Access Compliance Report Public Rights-of-Way (RR Crossings)

Intersection ID: 10032938	Main Street: NEW_BERN_ST	Location: N/A
ADA ID: 7F8C3354A18C	Overall Compliance: No	Severity Score: 0.0
Codes/Mitigation Info/Possible Solution		Field Measurements/Component Compliance

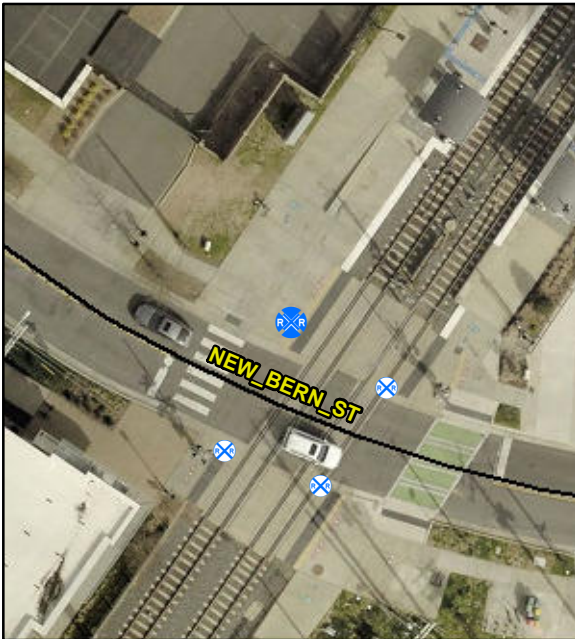
R302.7.4, R305.2.5

Compliance	Description	Data
Yes	DWS Provided?	Yes
Yes	DWS Contrast?	Yes
Yes	DWS Width (in)	Yes
Yes	DWS Length (in)	36.0
No	DWS Offset (in)	27.5
No	Pedestrian Gate?	No
N/A	DWS Outside Gate?	N/A
N/A	Rail Type?	LightRail
No	Flangeway Gap (in)	3.0
Yes	Sidewalk Width (in)	57.5

Remove & Replace Detectable Warning System. Provide Pedestrian Gate. Remove & Replace Walking Surface Adjacent to Rail.
